1 Products affected

2 Type of change

Product Change Notification					PCN 6200		
owner	creation date	release date	released by	change order no	rev	page	D10-004-681
schaidro	2016-05-30	2016-12-06	buerglal	2011605	A	1 of 2

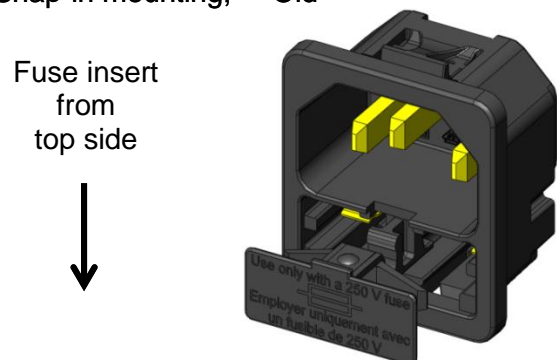
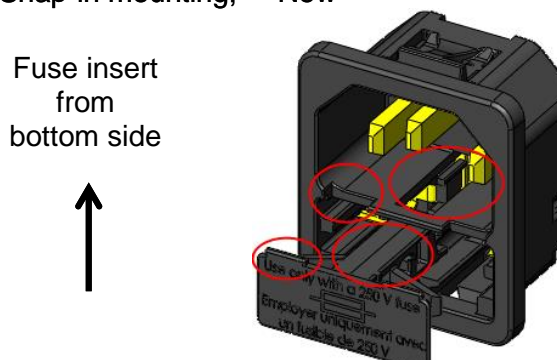
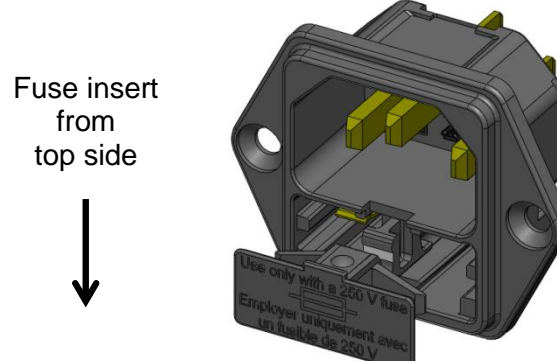
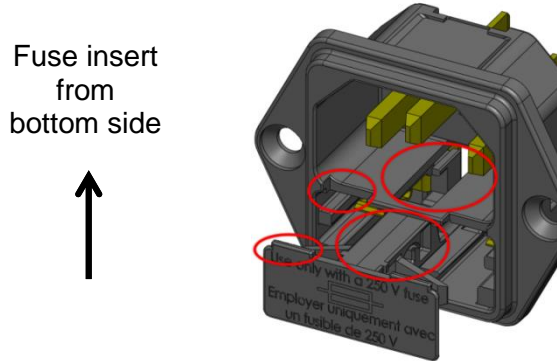
Old product appearance		New product appearance	
<ul style="list-style-type: none"> - Slot for V-Lock cord retention - Fuse assembling from opposite side - Fusedrawer has two latches on the side to pull-out the fusedrawer, until now is only one latch 			
Snap-in mounting; Old Fuse insert from top side 	Snap-in mounting; New Fuse insert from bottom side 		
Screw-on mounting; Old Fuse insert from top side 	Screw-on mounting; New Fuse insert from bottom side

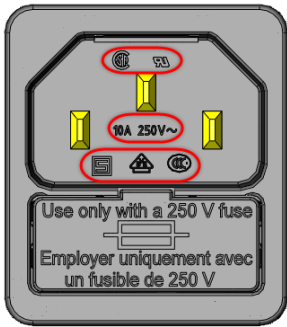
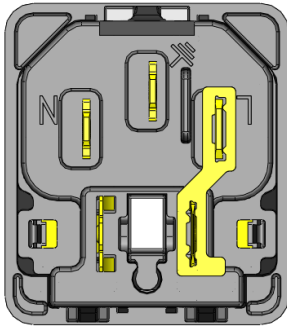
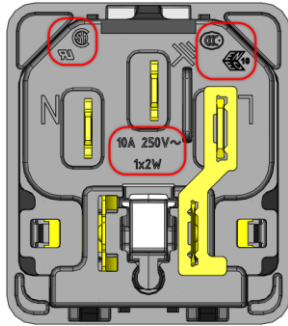
Old product approval marks	New product approval marks
<p>Picture shows snap-in mounting, change also applies to screw version. All approval and rating marks are new on the rear side</p>	
<p>Old;</p>  	<p>New;</p>
